# Access Compliance Report

## Public Rights-of-Way

### (Curb Ramps)

Intersection ID: 30412	Main Street: COVENTRY_ROW_CT	Cross Street: SARDIS_RD	Location: E
ADA ID: EF556DB3B712	Ramp Type: PerpDiag	Initial Pass/Fail: Fail	Overall Compliance: No
		Severity Score: 8.75

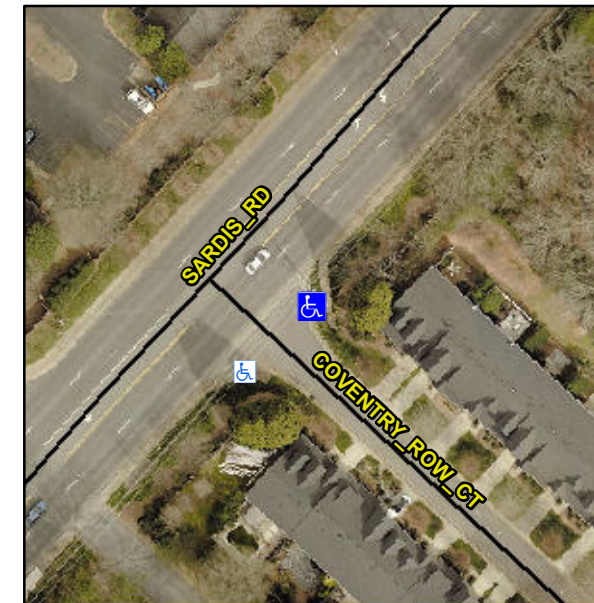
**Not Found, R304.5.1**

Compliance	Description	Data	Compliance	Description	Data
N/A	Ramp Length (in)	82.0	Yes	Ramp Slope (%)	8.0
No	Ramp Width (in)	39.0	Yes	Ramp XSlope (%)	2.0
N/A	Flare Type LT	N/A	N/A	Flare Type RT	N/A
N/A	Flare Slope LT (%)	N/A	N/A	Flare Slope RT (%)	N/A
N/A	Flare Traversable LT?	N/A	N/A	Flare Traversable RT?	N/A
N/A	Landing Length (in)	N/A	N/A	DWS Provided?	N/A
N/A	Landing Width (in)	N/A	N/A	DWS Contrast?	N/A
N/A	Landing Slope (%)	N/A	N/A	DWS Length (in)	N/A
N/A	Landing X Slope (%)	N/A	N/A	DWS Full Width?	N/A
N/A	Landing Curb? (Y/N)	N/A	N/A	DWS Offset (in)	N/A
N/A	Shared Landing?	N/A			
N/A	Gutter Ponding?	N/A	N/A	Gutter Slope (%)	N/A
N/A	Gutter Lip Ht (in)	N/A	N/A	Gutter X Slope (%)	N/A
N/A	Painted X Walk1?	No	N/A	Painted X Walk2?	No
	X Walk 1 Direction	To NW		X Walk 2 Direction	To SW
N/A	X Walk 1 Width (in)	N/A	N/A	X Walk 2 Width (in)	N/A
	X Walk 1 Slope (%)	0.6		X Walk 2 Slope (%)	0.9
	X Walk 1 X Slope (%)	1.1		X Walk 2 X Slope (%)	0.9

**Remove & Replace Curb Ramp With Two New Directional Ramps or Equivalent.**
